Women swimmers request an essential “change order” for the Barton Springs Pool Bathhouse Rehab

For consideration by the Parks Board and Council Members

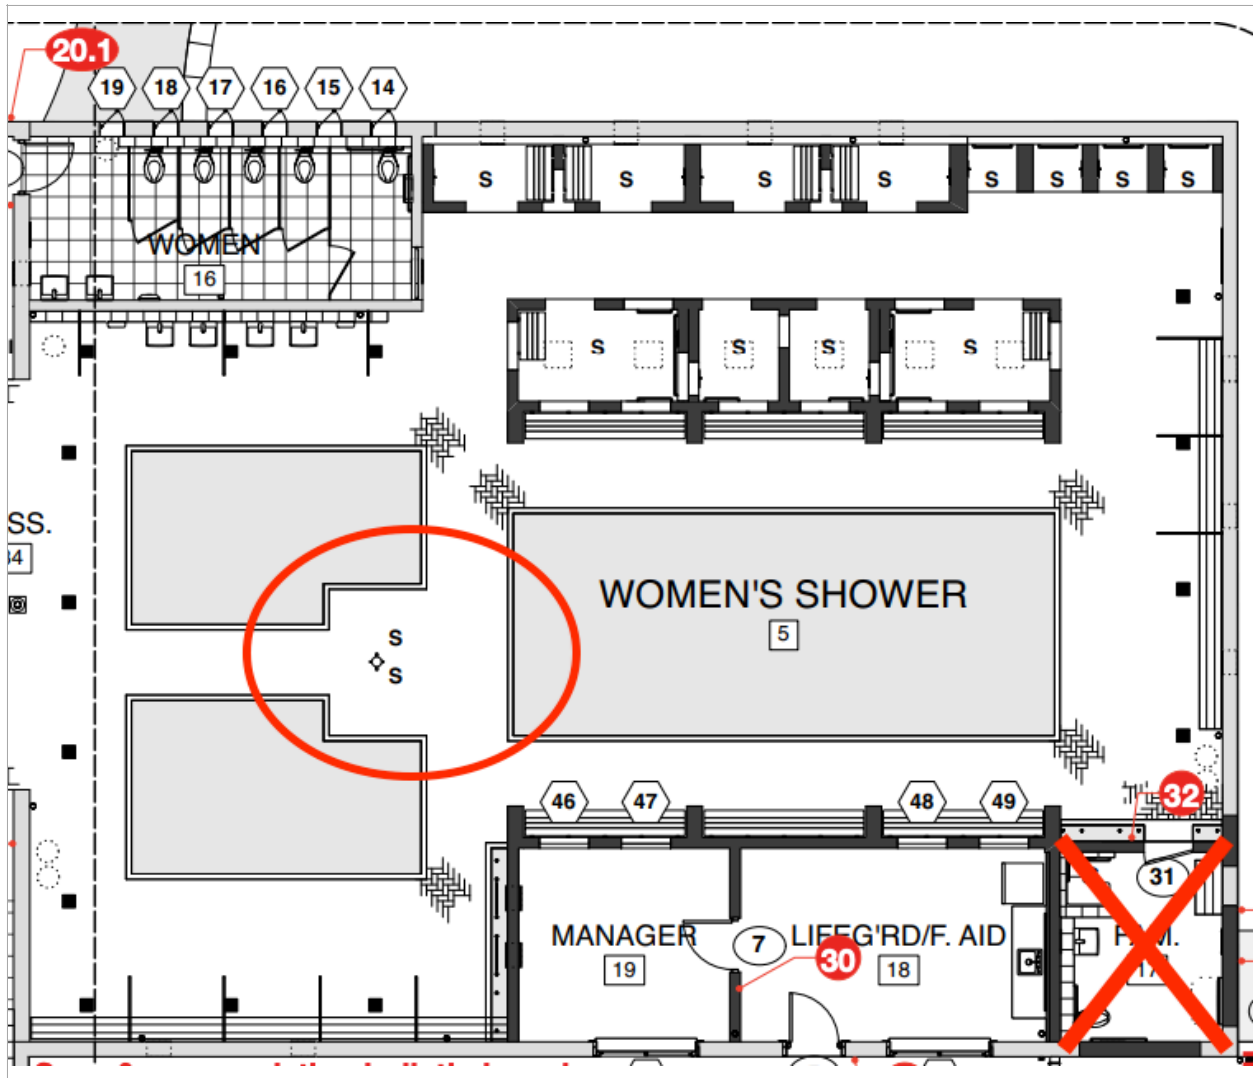
We are asking Council and the Parks Board to please ensure that the City Manager's Office directs the project team to remove the SE corner family restroom proposed for the women's shower and dressing area.

The “red oval” is the open-air women’s shower in the middle of the courtyard.

If family restroom #5 is intended to be used by families with young children, it violates the privacy of both the women showering and of the children.

The men’s courtyard has no such family restroom opening into their showers. Please give women the same privacy.

If family restroom #5 is intended to serve gender-fluid people, it fails the test because they have been forced to walk through the women’s corridor and showers.

To remove family restroom #5 is simple: Put an “X” over that corner. The contractor can then finish the room as staff space or storage. Removing family restroom #5 from the plan will certainly reduce cost with less plumbing, tile and fixtures.

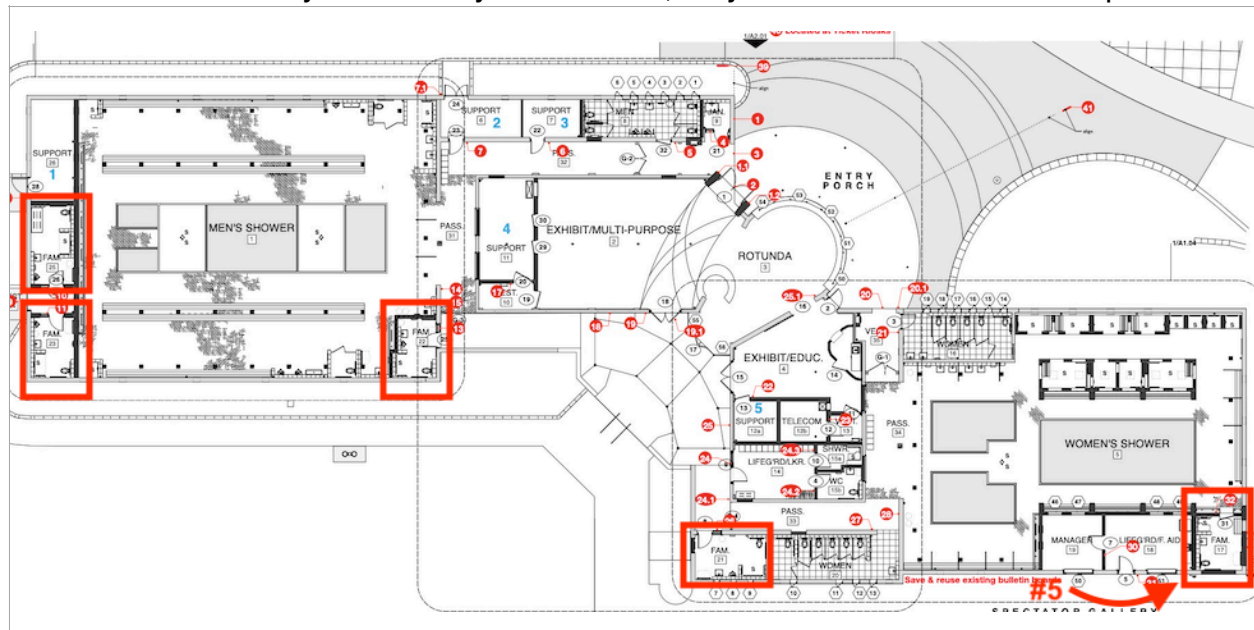
The existing women's corridor family restroom is frequently abused. Lifeguards are tasked with cleaning a family restroom when it looks like a crime scene with blood, feces and needles. Staff has explained to us: If they don't have time to clean it, they lock the door.
